1722a D7 Questions III

Aaron Gelter January 20, 2014

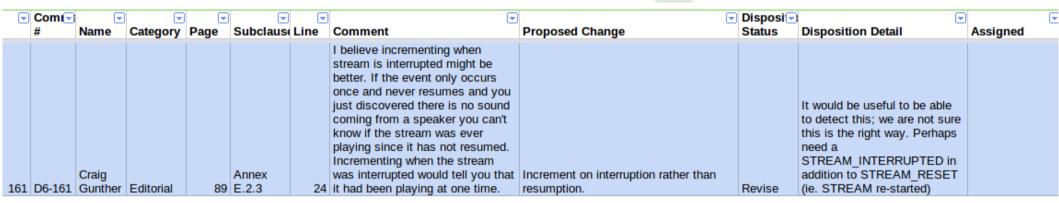
•	Comi #		Category	▼ Page	Subclaus Li	_ ine	Comment	Proposed Change	Disposi Status	Disposition Detail	Assigned	▼
151	D6-151	Ashley Butterwo	Technical	73	11.2		Why is the transmission rate limited to 8kHz? What if I want to transfer a much higher frequency clock.	Keep the lower limit but remove the upper limit.	Revise	Dave Olsen to follow up - Need presentations to be made during call - Recommend specific ranges for vaious clock types.	Dave

- Have we had any discussion about this?
- If not, upcoming call or defer to F2F?
